30 August 2024

Grey District Council  
c/- WePlan Ltd

## TRANSPORT REVIEW LANDUSE CONSENT FOR MEDICAL CENTRE 62 SHAKESPEARE STREET, GREYMOUTH

Figure 1: Site Plan / Layout [Source: Application Plans]

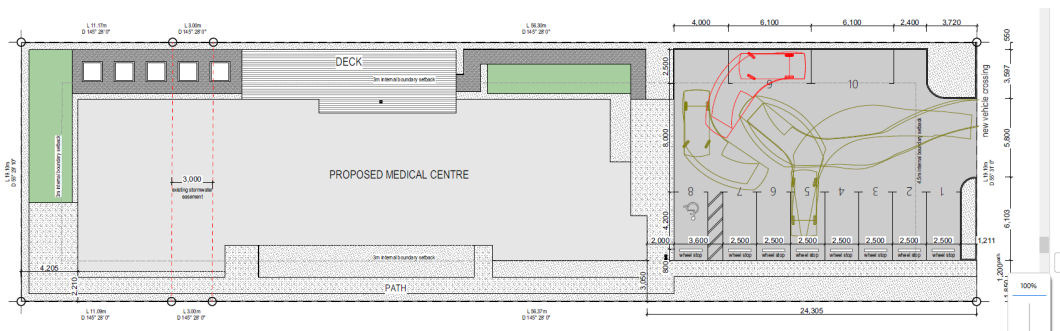
30. The site provides for 10 car parks with access to a *District Arterial* and as such 6.0m queuing space is required. The layout of the car park is such that the first point of potential conflict or control would arise from vehicles exiting the car parking spaces nearest to the road boundary. A vehicle entering the site may need to wait within the vehicle crossing, for these manoeuvres to be completed however such manoeuvres would be completed in a matter of seconds after which the two vehicles could pass on the access. As such any queuing would be momentary and not likely to have any noticeable impact on the level of service to any pedestrians. Vehicles queuing / waiting to enter the site would also be within the vehicle crossing and or parking lane and clear of the nearest traffic lane. As such no disruption to other traffic on Shakespeare Street is anticipated.

Figure 2: On-site Manoeuvring to Exit the Site in a Forward Gear [ASNZS2890.1 85<sup>th</sup> Percentile Design Vehicle]

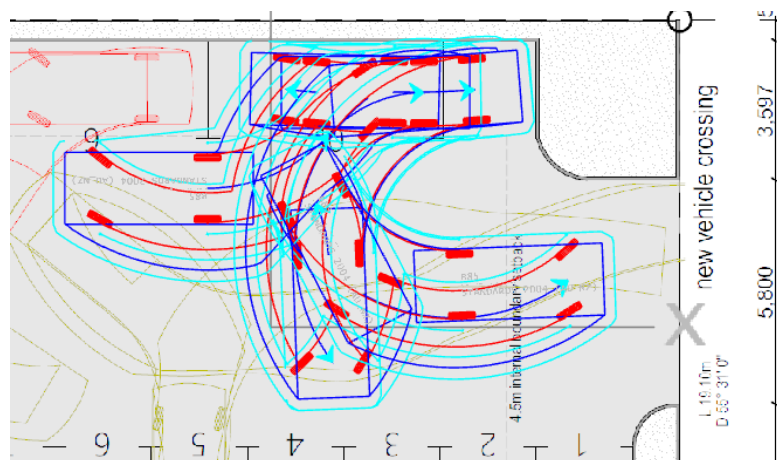
19. The on-site car parks are of complying dimensions and on-site manoeuvring is provided such that all vehicles can exit the site in a forward gear / direction. This includes the parallel car parks as shown in Figure 2.
